## Charlotte-Mecklenburg Planning Department

**SUBJECT:** Administrative Approval for Petition No. 2008-031 Mountain Island Promenade, LLC

Project: **RIVERBEND**  
MOUNT HOLLY-HUNTERSVILLE ROAD  
CHARLOTTE, NORTH CAROLINA

Title: **SITE PLAN FOR PHASE 1**

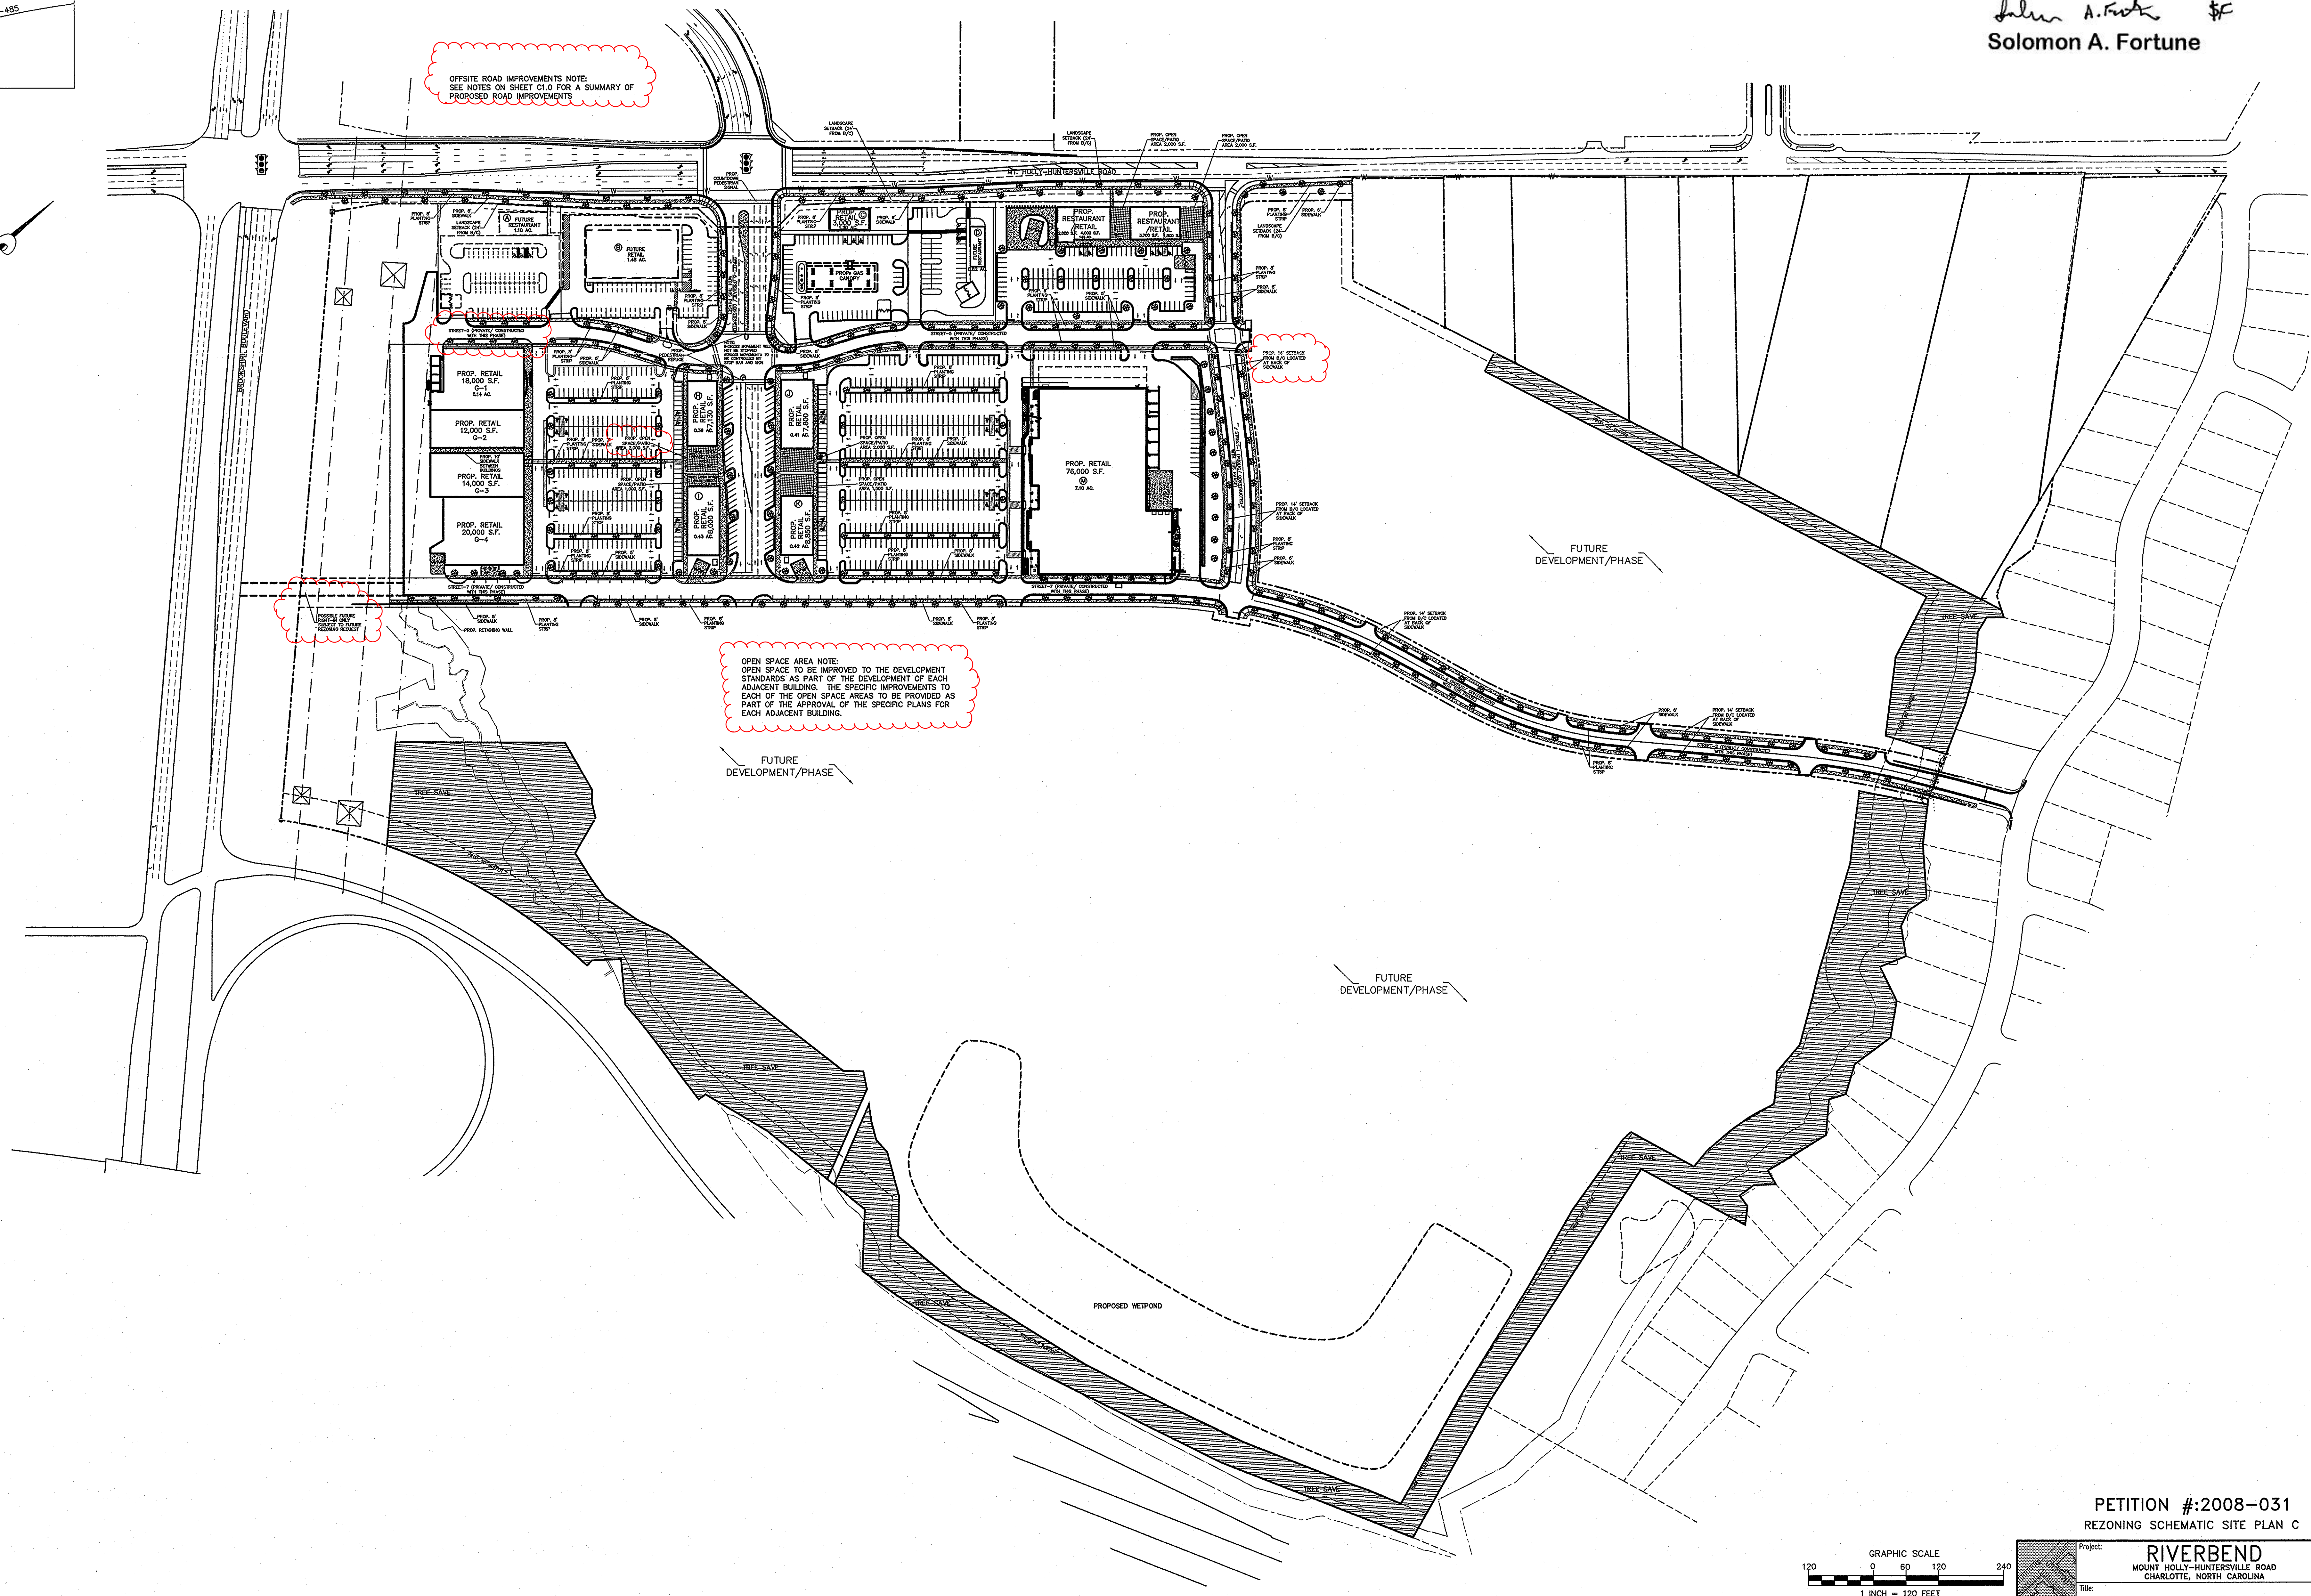
Attached is the revised site plan for the petition above. This request allows the modification of the proposed site plan as listed below. Since these changes do not alter the intent of the development and meets the requirements of the Charlotte Zoning Ordinance Section 6.207 Alterations to Approval, minor changes, I am administratively approving this plan. Please use these plans when evaluating requests for building permits and certificates of occupancy.

- General layout for proposed retail buildings.
- Note modification: Elevation and review will happen prior to commercial building standards review.
- Master site development record
- Open space and green areas are tied to certain buildings being developed.
- Screening wall along proposed internal public street
